# Access Compliance Report

## Public Rights-of-Way

### (Curb Ramps)

Intersection ID: N/A	Main Street: PAMPLIN_CT	Cross Street: PAISLEY_ABBEY_LN	Location: NE
ADA ID: D6880D3BD2A7	Ramp Type: Perp	Initial Pass/Fail: Fail	Overall Compliance: No
		Severity Score: 12.5

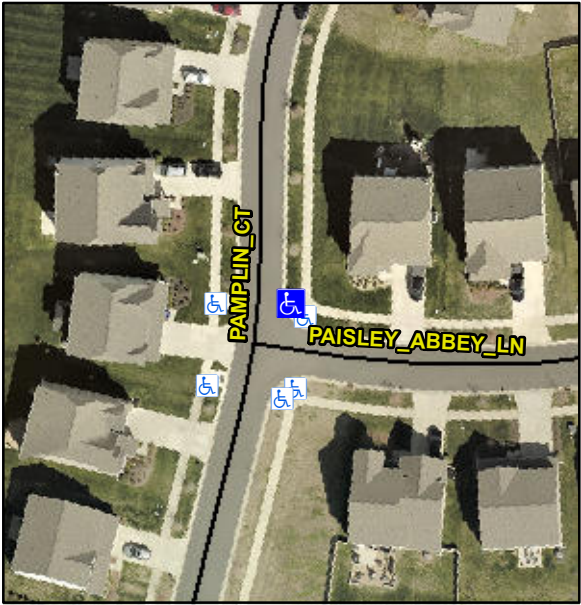
Codes/Mitigation Info/Possible Solution		Field Measurements/Component Compliance			
	Possible Solutions:				
	Remove & Replace Entire Ramp.				
	Surveyor Notes:				
	N/A				
	PROW/ADA:				
	Not Found, R304.5.3				
Street 1 Name	PAMPLIN CT				
Stop Condition-Street 2	None				
Street 2 Name	N/A				
Stop Condition-Street 1	N/A				
Total Cost:		\$	1850.00

Compliance	Description	Data	Compliance	Description	Data
N/A	Ramp Length (in)	98.5	Yes	Ramp Slope (%)	7.2
Yes	Ramp Width (in)	48.0	No	Ramp XSlope (%)	5.8
N/A	Flare Type LT	N/A	N/A	Flare Type RT	N/A
N/A	Flare Slope LT (%)	N/A	N/A	Flare Slope RT (%)	N/A
N/A	Flare Traversable LT?	N/A	N/A	Flare Traversable RT?	N/A
N/A	Landing Length (in)	N/A	N/A	DWS Provided?	N/A
N/A	Landing Width (in)	N/A	N/A	DWS Contrast?	N/A
N/A	Landing Slope (%)	N/A	N/A	DWS Length (in)	N/A
N/A	Landing X Slope (%)	N/A	N/A	DWS Full Width?	N/A
N/A	Landing Curb? (Y/N)	N/A	N/A	DWS Offset (in)	N/A
N/A	Shared Landing?	N/A			
N/A	Gutter Ponding?	N/A	N/A	Gutter Slope (%)	N/A
N/A	Gutter Lip Ht (in)	N/A	N/A	Gutter X Slope (%)	N/A
N/A	Painted X Walk1?	No	N/A	Painted X Walk2?	N/A
	X Walk 1 Direction	To NW		X Walk 2 Direction	N/A
N/A	X Walk 1 Width (in)	N/A	N/A	X Walk 2 Width (in)	N/A
	X Walk 1 Slope (%)	3.0		X Walk 2 Slope (%)	N/A
	X Walk 1 X Slope (%)	2.7		X Walk 2 X Slope (%)	N/A
